Project: IEEE P802.15 Working Group for Wireless Personal Area Networks (WPANs)

Submission Title: [Resolutions for the some comments related to MLME-DIMMER primitives]

Re: [Response to LB50 comments]

Resolutions for the some comments related to MLME-DIMMER primitives

Figure 61—Message sequence chart for performing the dimming function

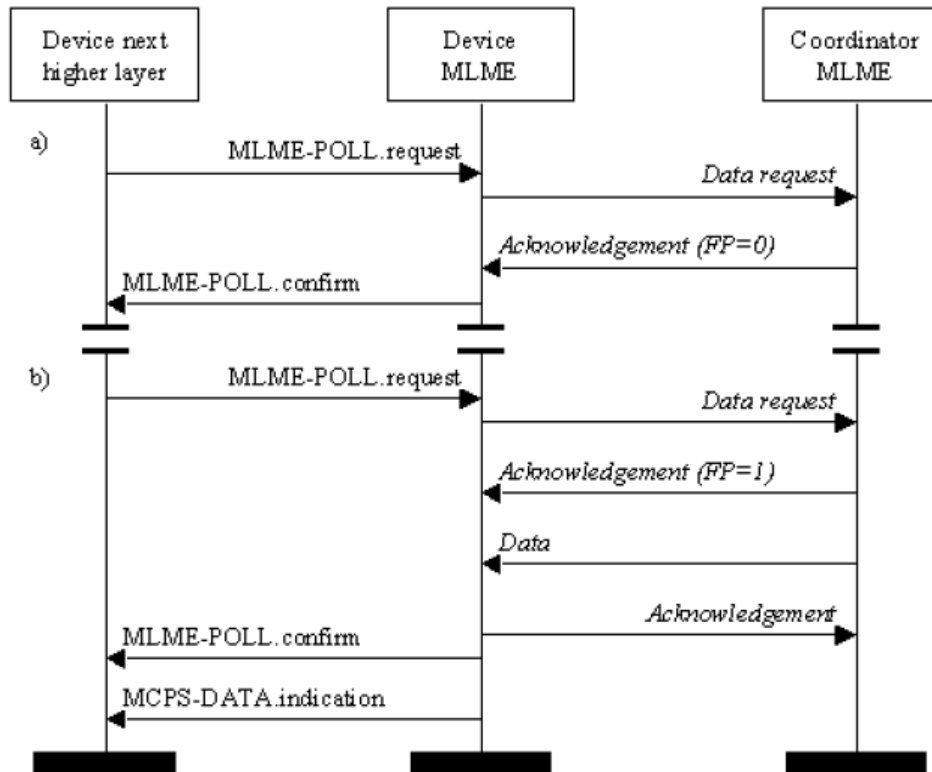
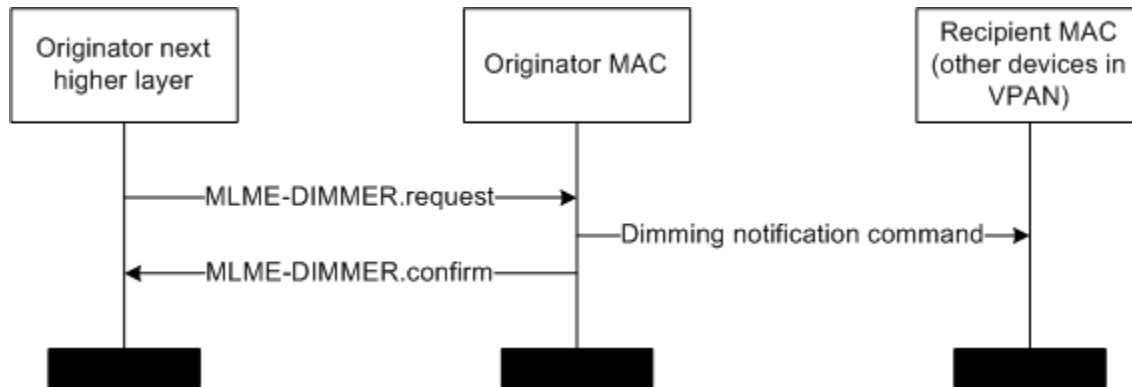
CID	Name	Clause	Subclause	Page	Line	Type	Comment	SuggestedRemedy
632	R. Roberts	7.1.16	Figure 61	129		T	Figure 61 is wrong	Figure 61 is wrong for the dimmer primitive ... update the figure.

[Ed. Note: This figure needs to be modified for the DIMMER primitive]

CID	Name	Clause	Subclause	Page	Line	Type	Comment	SuggestedRemedy
626	David Cypher	7	7.1.15.3	129	23	T	Figure 61 shows Message Sequence chart for requesting data from a coordinator, not performing the dimming function	replace "performing the dimming function" with "requesting data from a coordinator"

CID	Name	Clause	Subclause	Page	Line	Type	Comment	SuggestedRemedy
627	David Cypher	7	7.1.16	129	24	T	The editor's note is wrong and should be need to add a new figure showing dimming function	add new figure for dimming function as soon as some one knows what it does and the text is properly corrected.

CID	Name	Clause	Subclause	Page	Line	Type	Comment	SuggestedRemedy
631	Huan-Bang Li	7	1	129	24	T	the description in red color must be resolved.

CID	Name	Clause	Subclause	Page	Line	Type	Comment	Suggested Remedy
632a	Kinney		Figure 61	129	24	E	Figure 61 hasn't been modified to DIMMER primitive as per text "Ed. Note: This figure needs to be modified for the DIMMER primitive"	modify Figure 61 to accommodate DIMMER primitive

- This comment is related to figure 61.
- Figure 61 shows the message sequence chart for POLL function, not DIMMER function.
- So suggested remedy is to update the figure.
- **Recommendation/Instruction to editor**
 - In our opinion, this comment is correct.
 - We'd like to recommend that we accept this comment.

- We suggest new figure 61 for MLME-DIMMER primitives.
- The MLME-DIMMER.request primitive requests that the MLME perform the dimmer function.
- MAC layer sends a dimming notification command(7.3.10) to MAC of other devices in VPAN.
- MAC layer reports the results of a dimming request.

- This comment is related to figure 61.
- Comment means Figure 61 shows Message Sequence chart for requesting data from a coordinator, not performing the dimming function
- If we change the figure to new one, this comment does not need any more.
- **Recommendation/Instruction to editor**
 - In our opinion, this comment is correct.
 - We'd like to recommend that we accept this comment in principle.
 - However, if we accept CID 632 in previous slide, we do not need these suggested remedy no longer because the figure is modified to perform dimming function.
 - Accept in principle – the implementation of T-CID 632 will result in the modification of the problem; hence, closed

- This comment is related to figure 61.
- Suggested remedy is to add new figure for dimming function as soon as some one knows what it does and the text is properly corrected.
- **Recommendation/Instruction to editor**
 - In our opinion, this comment is correct.
 - We will update the figure 61.
 - We'd like to recommend that we accept this comment in principle.
 - Accept in principle – the implementation of T-CID 632 will result in the modification of the problem; hence, closed

- This comment is related to figure 61.
- Comment means that the description in red color must be resolved.
- The description in red color is editor note.
- **Recommendation/Instruction to editor**
 - In our opinion, this comment is correct.
 - We will update the figure 61.
 - We'd like to recommend that we accept this comment in principle.
 - Accept in principle – the implementation of T-CID 632 will result in the modification of the problem; hence, closed

- This comment is related to figure 61.
- Suggested remedy means that modify Figure 61 to accommodate DIMMER primitive.
- **Recommendation/Instruction to editor**
 - In our opinion, this comment is correct.
 - We will update the figure 61.
 - We'd like to recommend that we accept this comment.
 - Accept in principle – the implementation of T-CID 632 will result in the modification of the problem; hence, closed
